bb-ldo — Design Document

PCB-0012-A

bb-ldo - requirements (P0)

reports/renders/bb-ldo_top.png

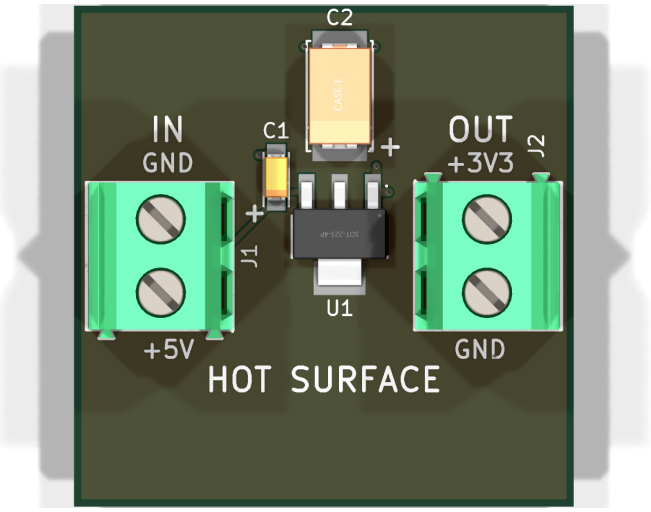
Capacitor polarity, after assembly. C2's added + at (24.800, 29.400) is directly over pad 1 at x=24.788 - the anode, on +3V3 - 0.52 mm clear of the body silk and outside the courtyard, so it is visible with the part fitted (bb-ldo_top.png, and the zoomed body in the centre crop shows the model's own light anode stripe on that same right-hand end, agreeing with the mark). C2's native marks are indeed useless: the band at local x=+2.20 is under the 7.3 x 4.3 body and the pin-1 dot is a 0.03 mm radius circle. C1 needs no added mark - its footprint's own + glyph lands at (29.500, 38.810), outside its courtyard on the anode side, and its model stripe agrees. **Both correct and both legible.**

reports/renders/bb-ldo_bottom.png

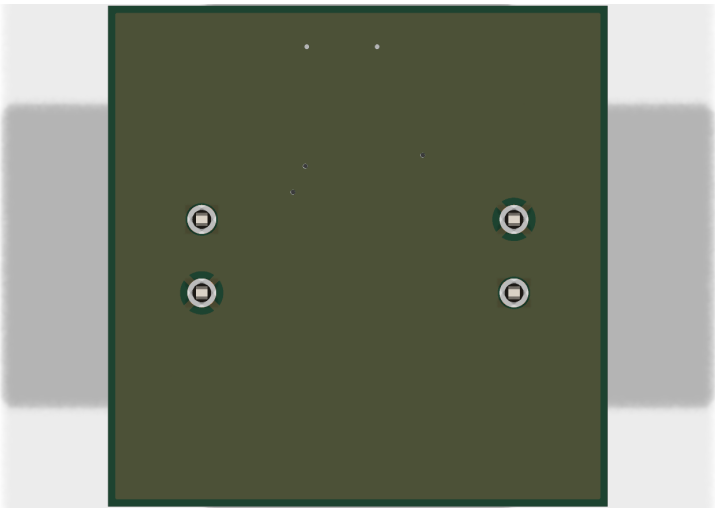
- `J1.2` (GND) and `J2.2` (GND) are both `thru_hole` pads with `(layers "*.Cu" "*.Mask")`, i.e. their barrels penetrate F.Cu and B.Cu directly. Confirmed visually in `bb-ldo_bottom.png`: both show a four-spoke thermal relief into the plane, while J1.1 (+5V) and J2.1 (+3V3) show an isolating antipad.

Hand-solder access. J1 and J2 are the only hand-soldered parts and they solder from the bottom, where B.Cu carries nothing but the GND plane and three tented vias - no SMT parts, no obstructions (bb-ldo_bottom.png). C1 and C2 are on the opposite face, 8.3 mm and further from the nearest THT pin; **an iron at J1 or J2 cannot reach them.** The only hand-solder problem on this board is F3.
